Form 3160-5
(June 2015)UNITED STATES
DEPARTMENT OF THE INTERIOR
BUREAU OF LAND MANAGEMENTFORM APPROVED
OMB No. 1004-0137
Expires: January 31, 2018**SUNDRY NOTICES AND REPORTS ON WELLS**
Do not use this form for proposals to drill or to re-enter an abandoned well. Use Form 3160-3 (APD) for such proposals.

8. Well Name and No. CATO SAN ANDRES UNIT #113

9. API Well No. 30-005-20211

**Cato San Andres Unit 113
30-005-20211
Oxy USA Incorporated
July 21, 2022
Conditions of Approval**

Current

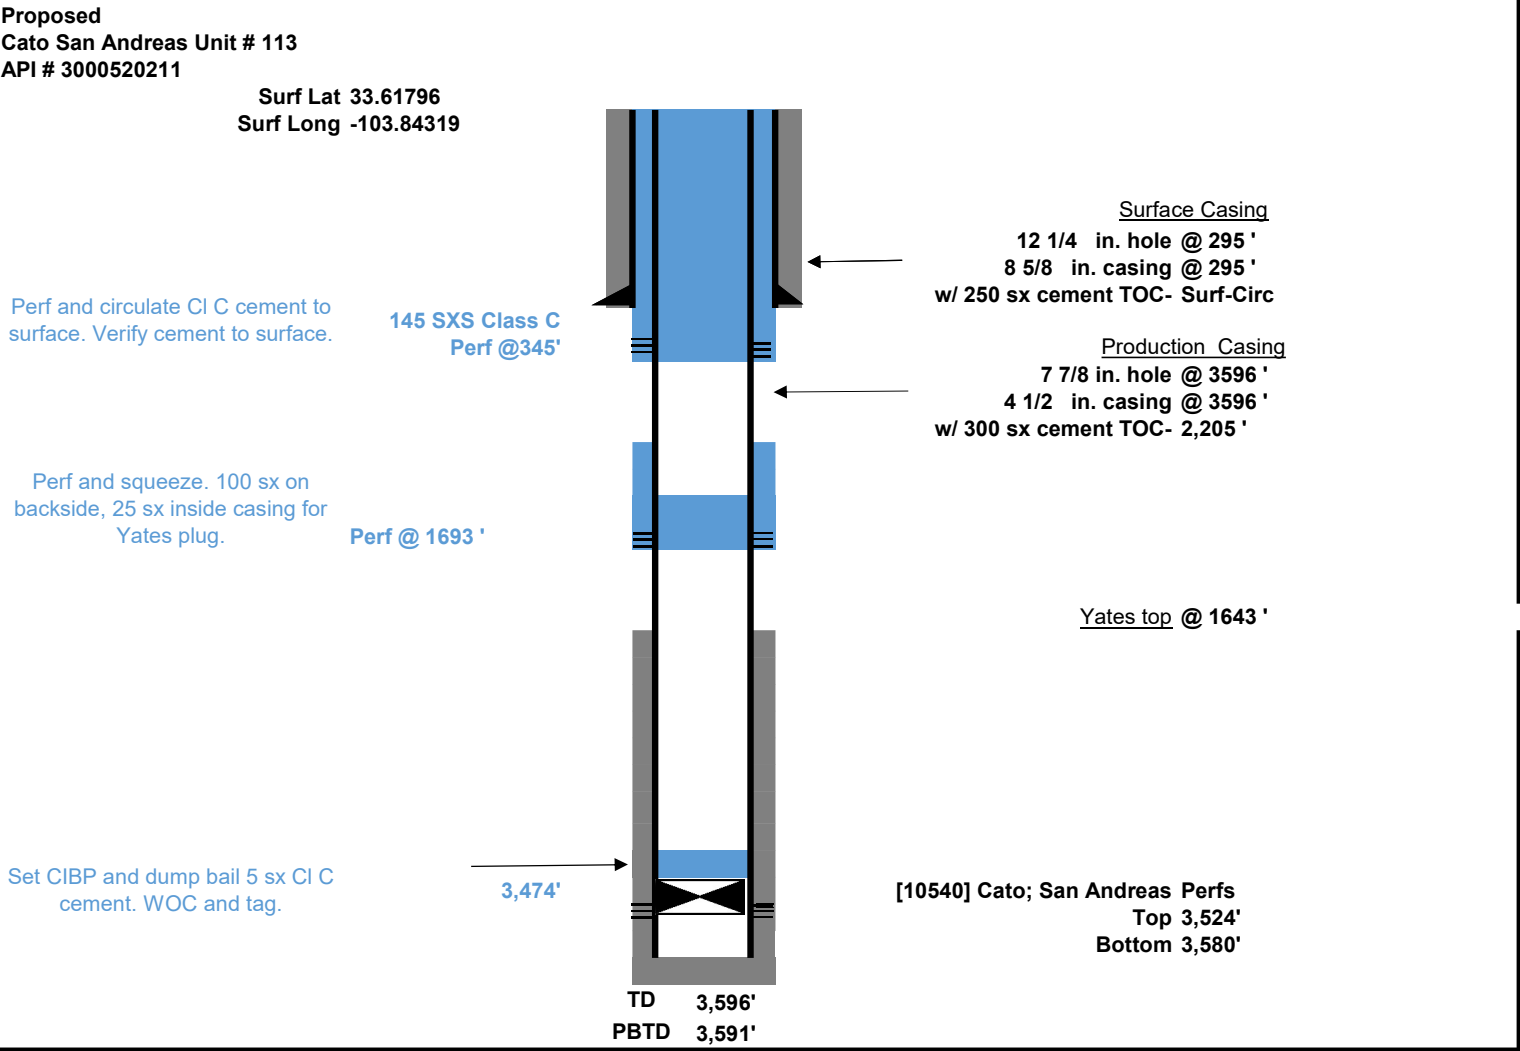
- 1. Operator shall place CIBP at 3,474' (50'-100' above top most perf) and place a minimum of 25 sx of Class C cement on top. WOC and TAG.**
- 2. Operator shall perf at 1693' and squeeze class C cement to 1,570' to seal the Yates formation. Yates formation top at 1,643' must be isolated.**
- 3. Operator shall perf at 345' and squeeze class c cement to surface to seal the 8-5/8" casing shoe.**
- 4. Dry hole marker must be below ground.**
- 5. Surface reclamation will need to be completed once the well bore has been plugged. Please contact rflores@blm.gov for additional information.**
- 6. See Attached for general plugging stipulations.**
